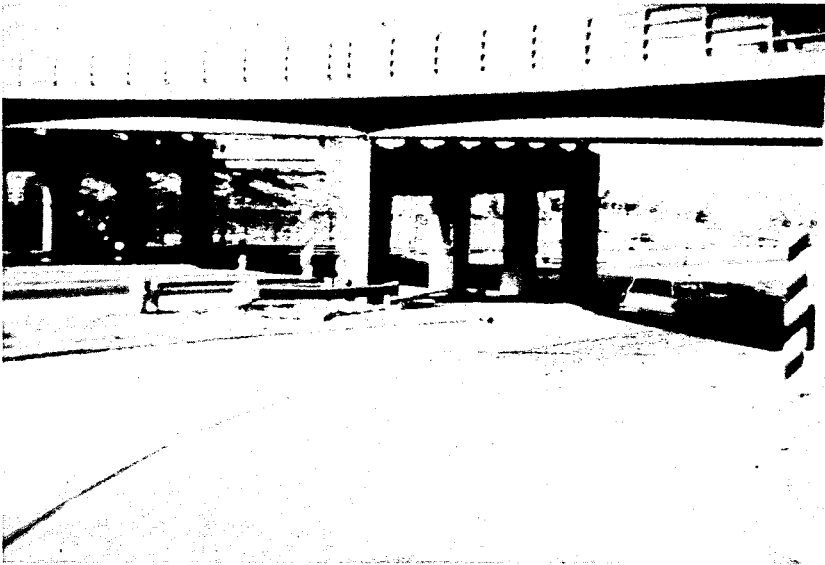
Here you can see the guardrail protecting the first post on a downhill turn, and there is a tapered curb. They must not be interested in the other three posts. That guardrail has been damaged and it is being replaced at this time. They still neglect to see the other three posts, and it was replaced just the way it was before. The rail is too short.

Here you see three posts; the one with the dot, the middle one, has been hit; there is a black spot on it near the bottom. This is Interstate 287; we fail to provide sliding action and protection at these poles.
